WILLIAMSON COUNTY, TEXAS

CHANGE ORDER NUMBER: 13

Project: 08WC608

Roadway: Westinghouse Rd

6. Work to be performed in accordance with Items: See Attached
7. New or revised plan sheet(s) are attached and numbered: 158
8. New Special Provisions to the contract are attached: ☐ Yes ☒ No

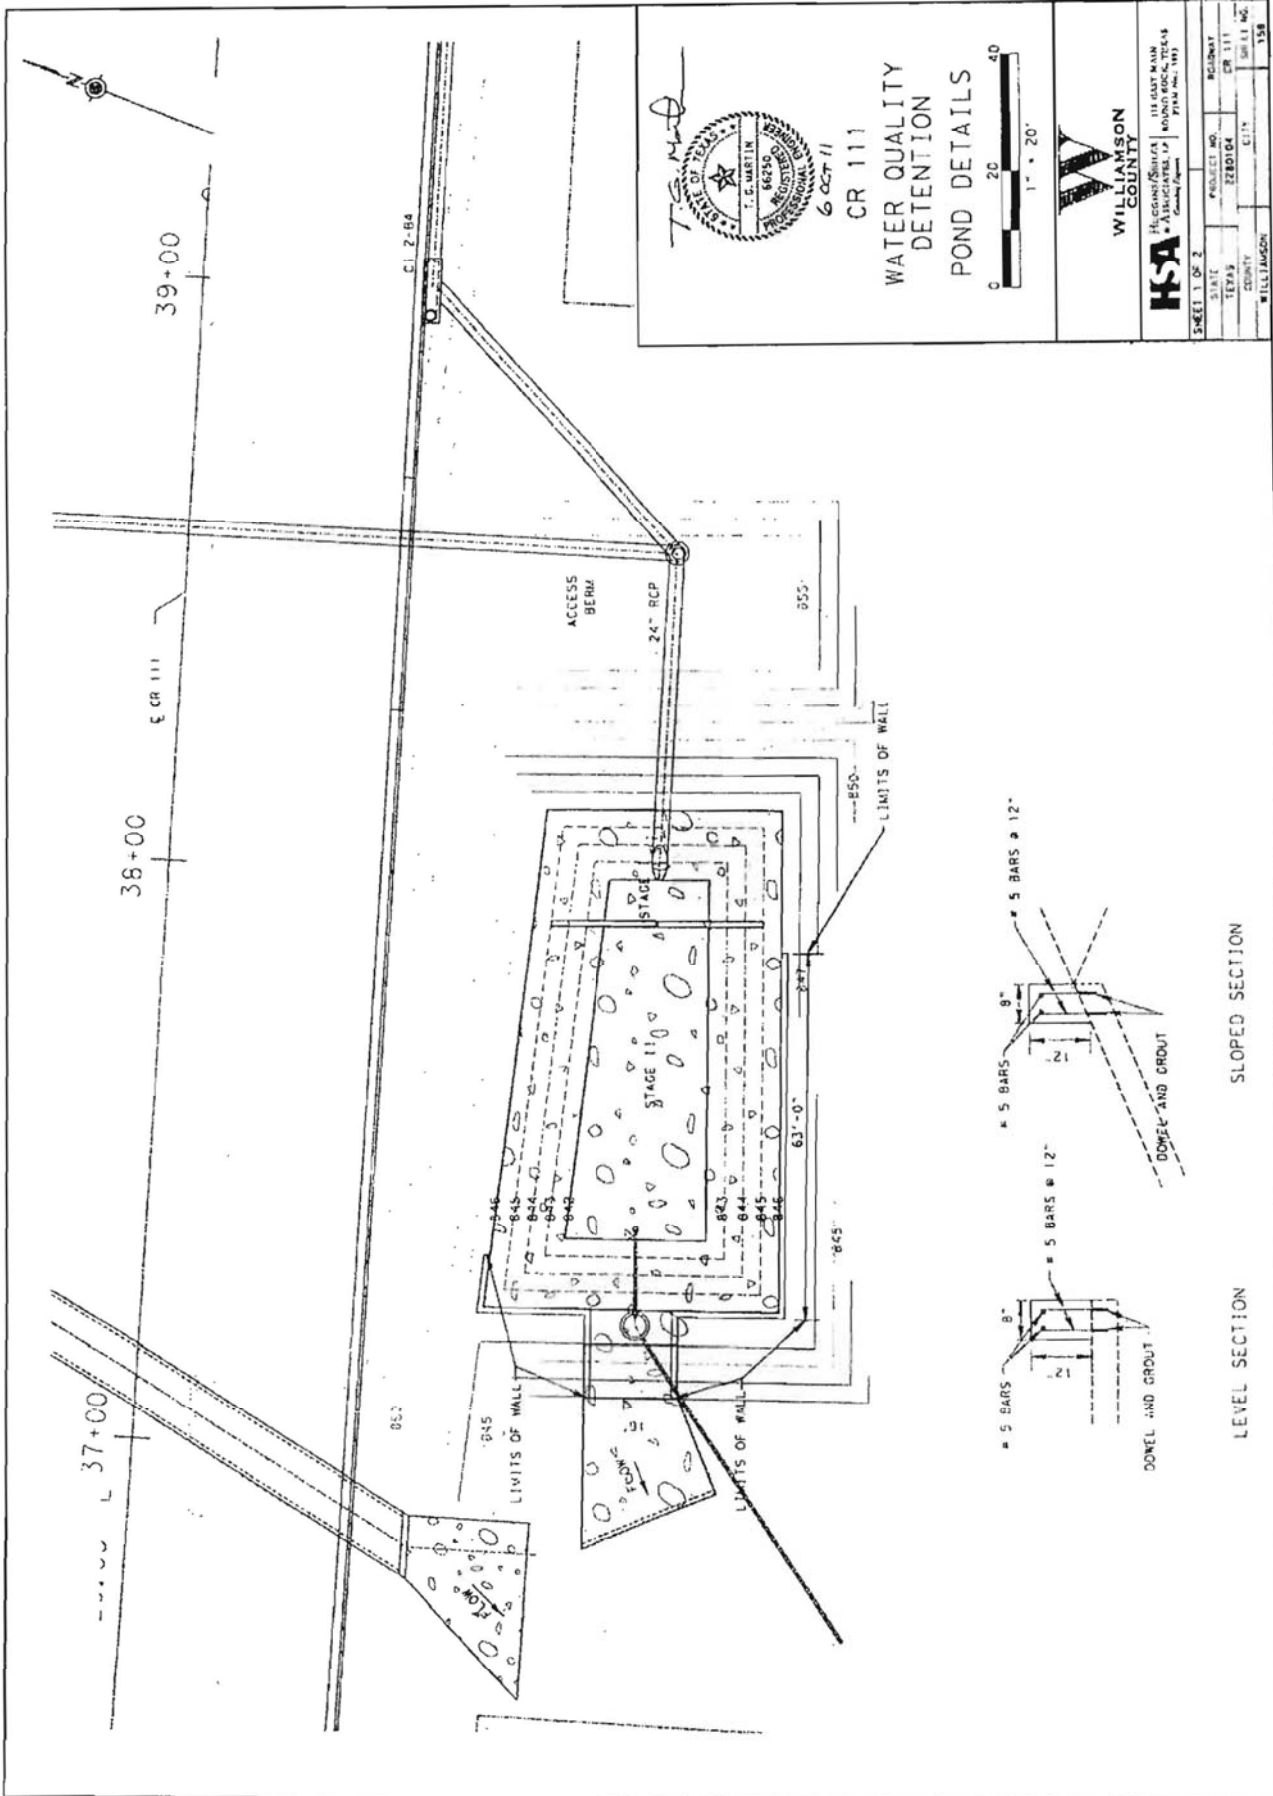
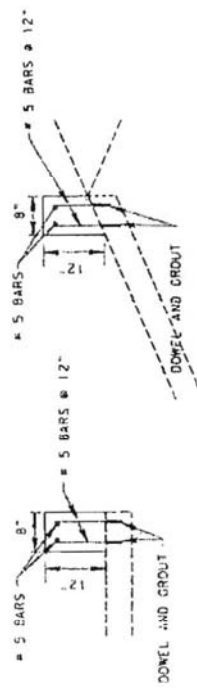
This Change Order compensates the Contractor for additional work related to revisions to the outfall of the detention pond, including mobilization, drilling, dowels, grout, rebar, forms, concrete, and backfill behind the pond curb.

ITEM	DESCRIPTION	QTY	UNIT
9999-113	DETENTION POND MODIFICATIONS	1	LS
